# Access Compliance Report

## Public Rights-of-Way

### (Curb Ramps)

Intersection ID: 8816	Main Street: BROOKSTEAD_MEADOW_CT	Cross Street: NORKETT_DR	Location:	N
ADA ID: 57C9FD4802DD	Ramp Type: Perp	Initial Pass/Fail: Fail	Overall Compliance: No	Severity Score: 8.75
Codes/Mitigation Info/Possible Solution		Field Measurements/Component Compliance

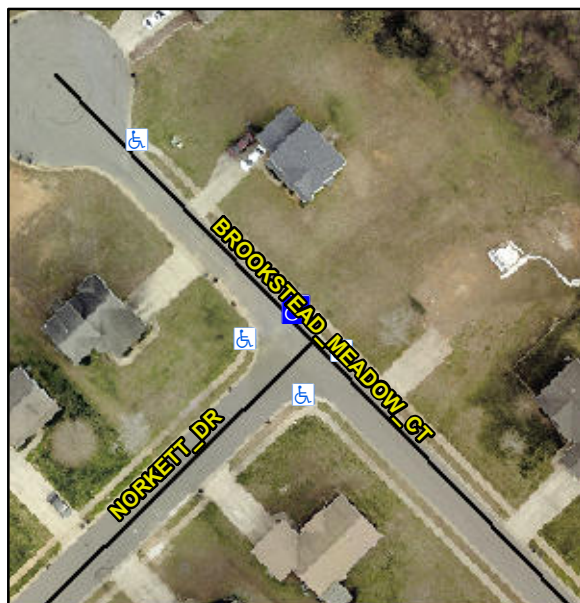
**Not Found, R304.5.1**

Compliance	Description	Data	Compliance	Description	Data
N/A	Ramp Length (in)	48.5	Yes	Ramp Slope (%)	7.6
No	Ramp Width (in)	44.0	Yes	Ramp XSlope (%)	1.4
N/A	Flare Type LT	N/A	N/A	Flare Type RT	N/A
N/A	Flare Slope LT (%)	N/A	N/A	Flare Slope RT (%)	N/A
N/A	Flare Traversable LT?	N/A	N/A	Flare Traversable RT?	N/A
N/A	Landing Length (in)	N/A	N/A	DWS Provided?	N/A
N/A	Landing Width (in)	N/A	N/A	DWS Contrast?	N/A
N/A	Landing Slope (%)	N/A	N/A	DWS Length (in)	N/A
N/A	Landing X Slope (%)	N/A	N/A	DWS Full Width?	N/A
N/A	Landing Curb? (Y/N)	N/A	N/A	DWS Offset (in)	N/A
N/A	Shared Landing?	N/A			
N/A	Gutter Ponding?	N/A	N/A	Gutter Slope (%)	N/A
N/A	Gutter Lip Ht (in)	0.5	N/A	Gutter X Slope (%)	N/A
N/A	Painted X Walk1?	No	N/A	Painted X Walk2?	N/A
	X Walk 1 Direction	To SW		X Walk 2 Direction	N/A
N/A	X Walk 1 Width (in)	N/A	N/A	X Walk 2 Width (in)	N/A
	X Walk 1 Slope (%)	1.0		X Walk 2 Slope (%)	N/A
	X Walk 1 X Slope (%)	0.4		X Walk 2 X Slope (%)	N/A

**Remove & Replace Entire Ramp.**
